Proposal for amendments to UN Regulation No. 58.03

Rear Underrun Protection Device

The text reproduced below is prepared by the Netherlands to amend the provisions for the position of the Rear Underrun Protection Device. The modifications to the current text of UN Regulation No. 58 are marked in bold characters and in strikethrough for deleted characters.

Figure (1) current situation

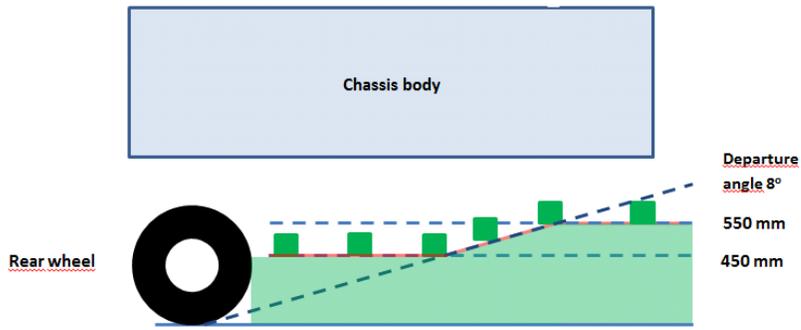
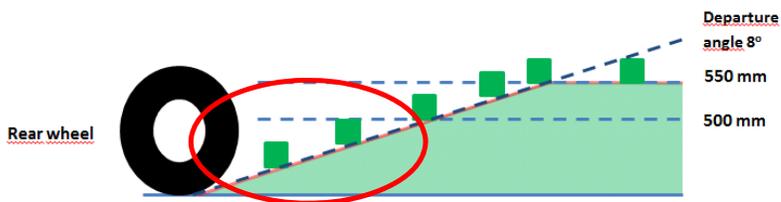
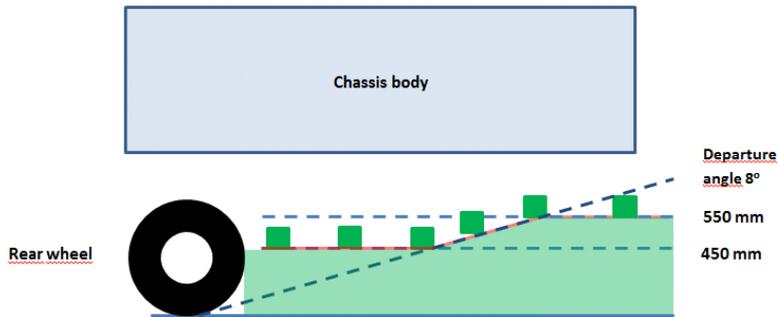
Section (a) and (b) state the requirements for ground clearance of the RUPD. Section (a) is for hydro pneumatic, hydraulic or pneumatic suspensions and section (b) for all others. When you illustrate the requirements in an image, you will get the image as shown in figure 1. Beside the height difference (450 to 500 mm) you can clearly see the difference.

According section (b) the maximum ground clearance shall not exceed 500 mm or shall not exceed a departure angle of 8° (whichever is less). This will result in that if you mount the RUPD directly behind the rear axle, the ground clearance will be far less than 500 mm. due to the departure angle of 8°.

The Netherlands believes that this is not the intention of the Regulation.
Amending the paragraphs as suggested lead to the image as shown in figure 2.

(b) 500 mm for vehicles other than those in (a) above. In any case, a departure angle up to 8° according to ISO 612:1978 with a maximum ground clearance of 550 mm shall be deemed to satisfy the requirements.”
